COUNTY OF SANTA CRUZ

HISTORIC RESOURCES COMMISSION PLANNING DEPARTMENT

HISTORIC RESOURCE PRESERVATION PLAN REVIEW

Applicant:Heidi Spicer
Owner:Ayshe Tuncer and Mike Anderson
APN:041-021-41
Situs:8057 Valencia St., Aptos, CA
Location:The residence is located on the north side of Valencia St. approximately 200 feet east of Trout Gulch Rd.
Historic Name: None
Rating:..... NR3

FIGURE A

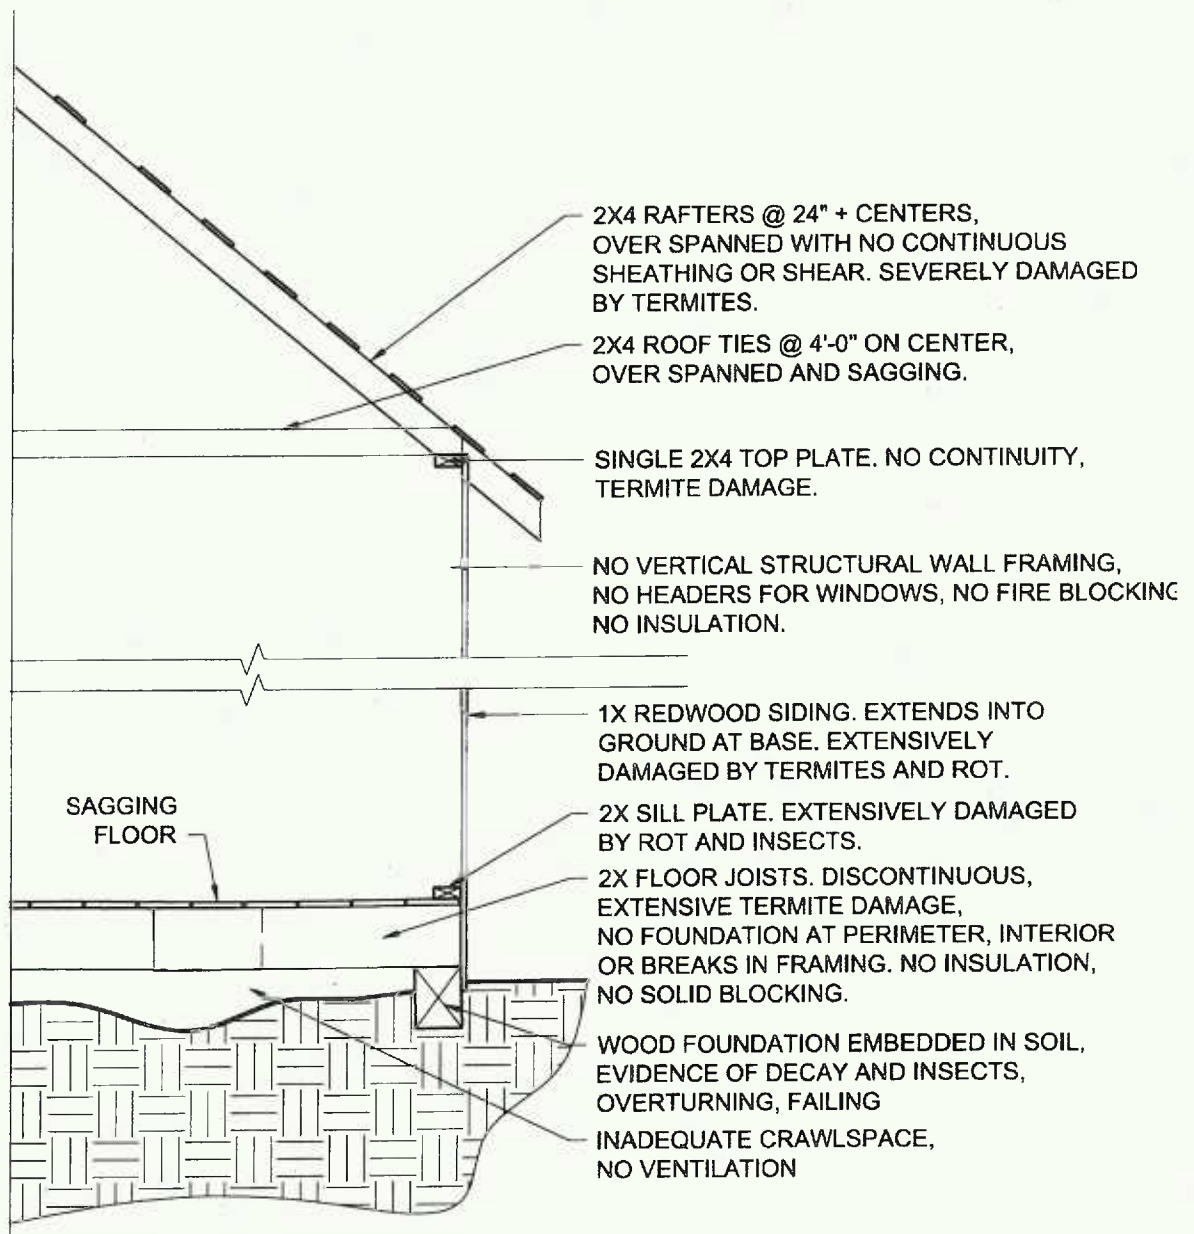
I provide the accompanying details to illustrate how buildings generally are constructed and how they behave under seismic loading. For comparison, I also show in Figure A – SKEC how the existing structure is put together. While we do not experience earthquakes every day, they are a significant consideration in structural design and building construction. Even historic structures must to a significant extent consider this in terms of life safety.

Figure A SKEC shows the structure's existing construction. There is no wall framing. The top plate is a single member only with nothing to keep gaps from opening up where it is discontinuous. There are several basic building components missing, including wall framing,

FIGURE B

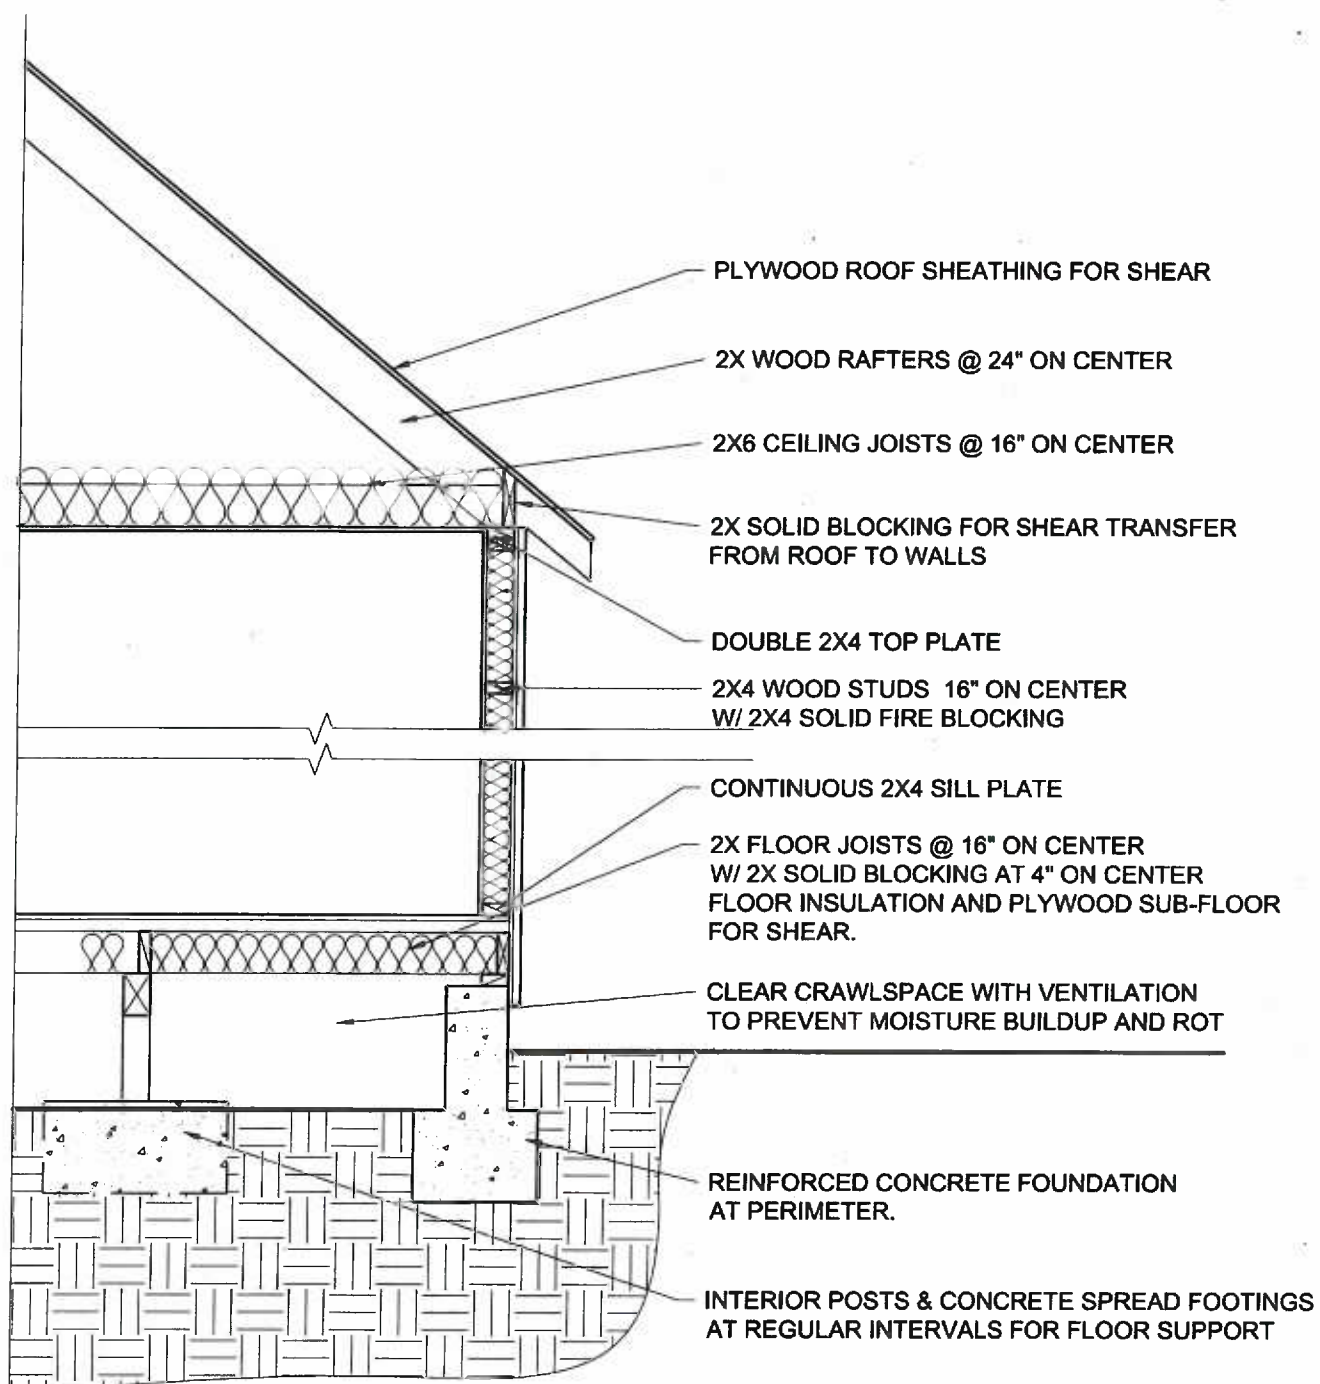
Figure B – SK1 shows a typical wall section based upon the minimum standards of the California Uniform Building Code. The significant difference from Figure A – SKEC includes wood stud wall framing, fire blocking, a double 2x4 top plate which provides a continuous 'collar' around the top of the wall which will not open up at breaks. 4'x8' plywood sheets, nailed continuously at all edges and at interior wood studs creates a 'shear panel', which resists racking and collapse.

FIGURE C CONSTRUCTION W/ 4'X8' PLYWOOD NO SCALE

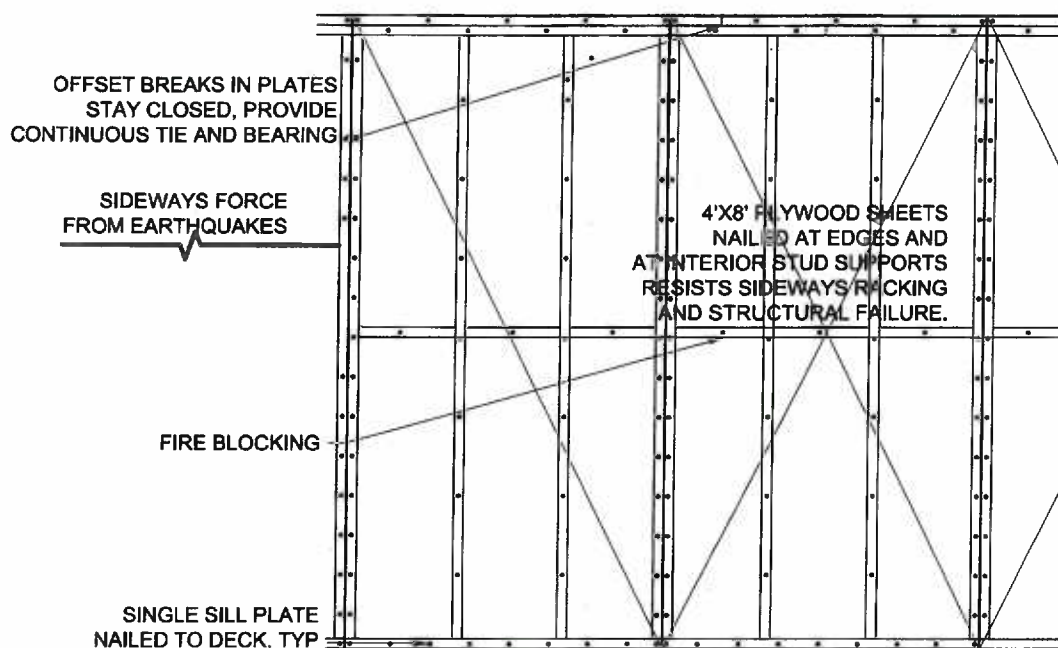
Figure C – SK2 shows an elevation of a typical wood framed wall built to the **minimum standards of the California Uniform Building Code**. Observing how the 4' x 8' sheet of plywood is fastened to the wood studs of the wall framing, one may intuit how the plywood resists racking when subjected to sideways earthquake forces. Figure D – SK2 shows how 1x12 boards, nailed only at the top and bottom will rack and collapse under the same forces which is why they are no longer allowed as structural siding under the current code.
